City of Portland, Oregon
Bureau of Development Services
Land Use Services
FROM CONCEPT TO CONSTRUCTION

NOTICE OF A TYPE II DECISION ON A PROPOSAL IN YOUR NEIGHBORHOOD

CASE FILE NUMBER: LU 19-209507 AD

Site Address: 430 NW Macleay Boulevard

*EXHIBIT C-1
19-209507 AD*

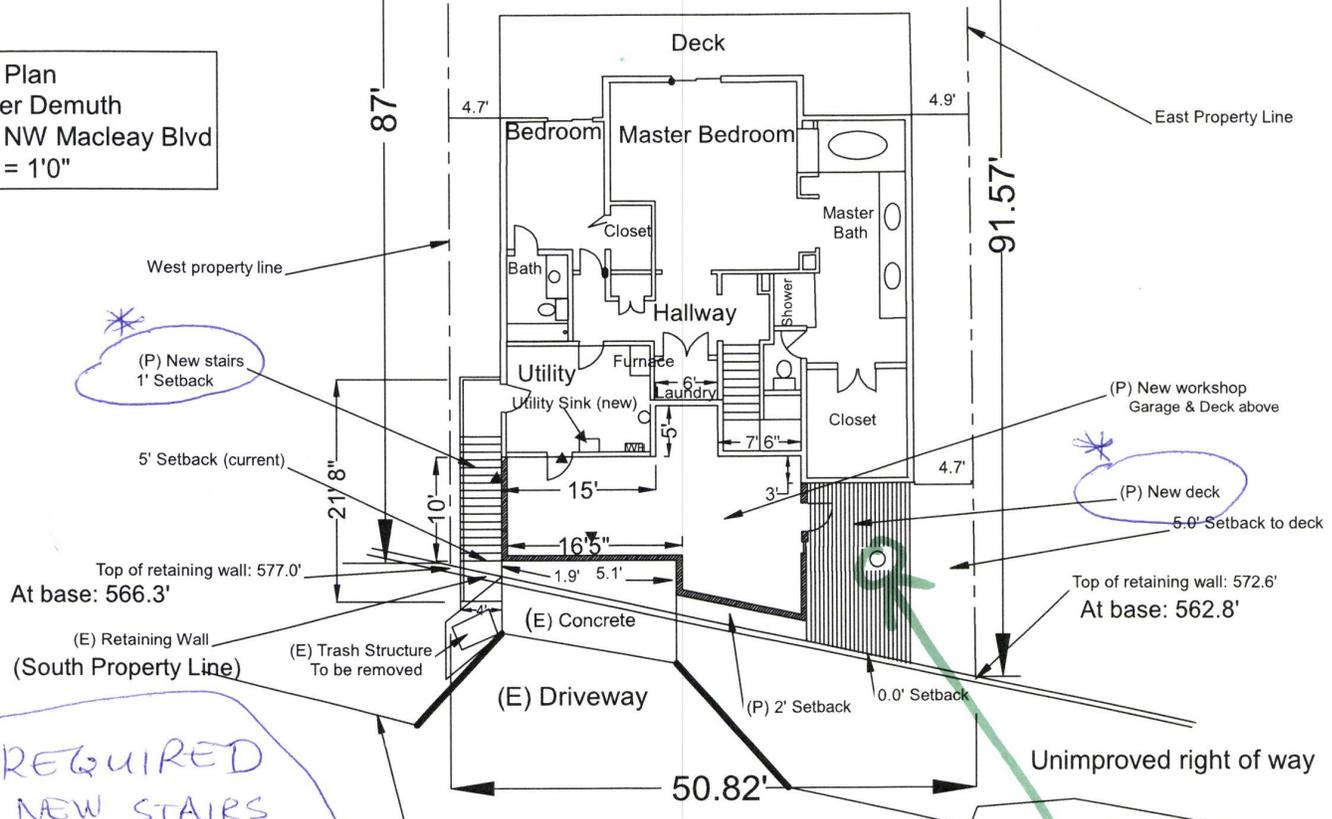
REQUIRED
 * NEW STAIRS
 AND NEW DECK
 MUST BE UNCOVERED -
 PER
 CONDITION C

REQUIRED:
 EXISTING
 18" MAPLE TO
 BE PRESERVED
 AND PROTECTED
 PER CONDITION B

- A certified arborist's report using the Performance Path of Section 11.60.030.C.2 for protection of the existing 18-inch maple tree located in the front setback area of the site.

- C. The new west stairway must remain uncovered above the stairs and open below the stairs. The new front lower deck must remain uncovered.

*19-209507 AD
EXHIBIT C-2*

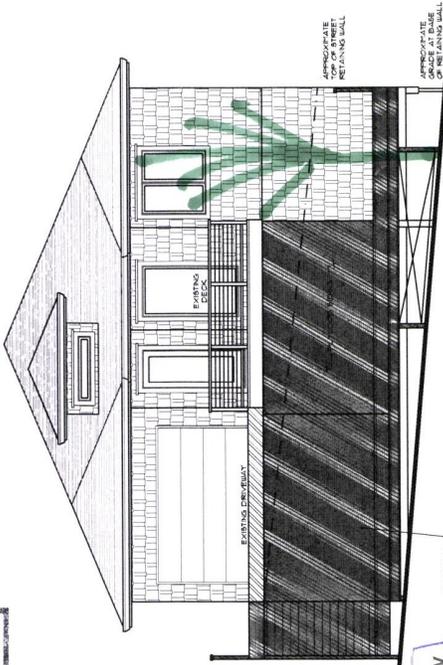
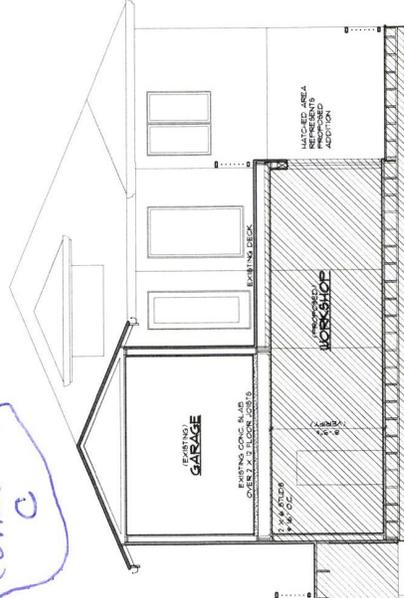
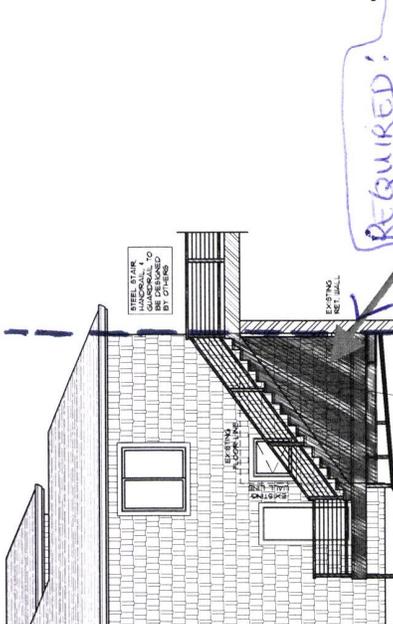
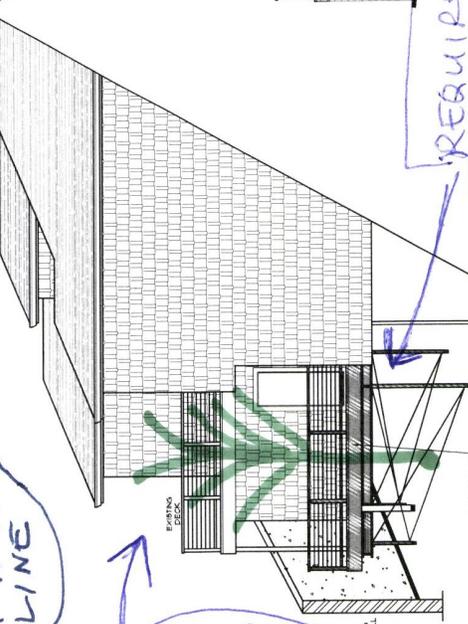
REQUIRED: Under side of stairway will not be enclosed, and will not be covered per Condition C

REQUIRED EXISTING 18" MAPLE TO BE PROTECTED PER CONDITION B

REQUIRED LOWER DECK WILL NOT BE COVERED PER CONDITION C

19.209507AD
 EXHIBIT C-3

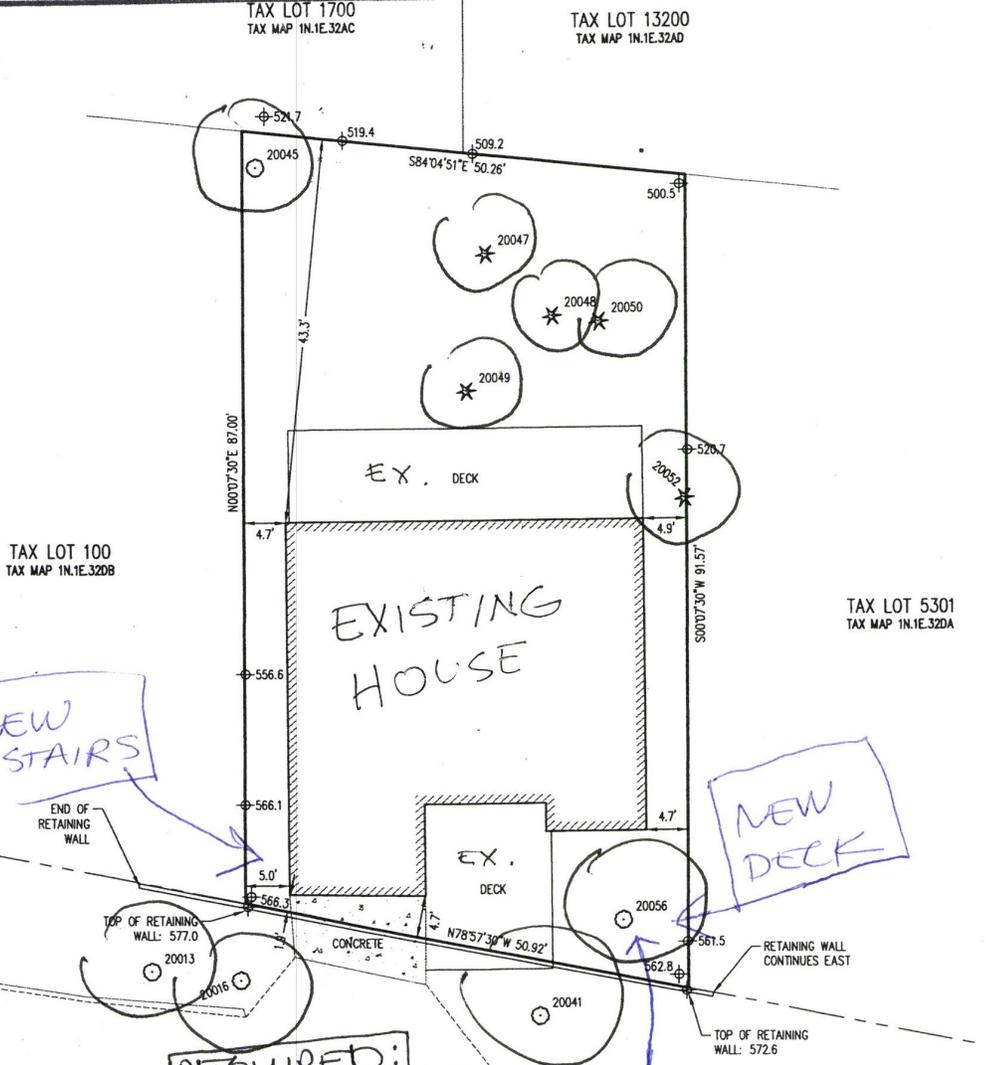
REQUIRED:
 CERTIFIED ARBORIST REPORT REQUIRED FOR TREE PROTECTION PER CONDITION B

REQUIRED:
 EXISTING TREES REQUIRED TO BE PRESERVED PER CONDITION B

- B. Existing trees on the site as shown on Exhibit C-3 must be preserved. At the time of building permit application, the applicant must submit:
 - A tree plan in compliance with Section 11.50.070, that confirms all existing trees will be preserved, excepting trees determined to be dead, dying or dangerous by a certified arborist; and
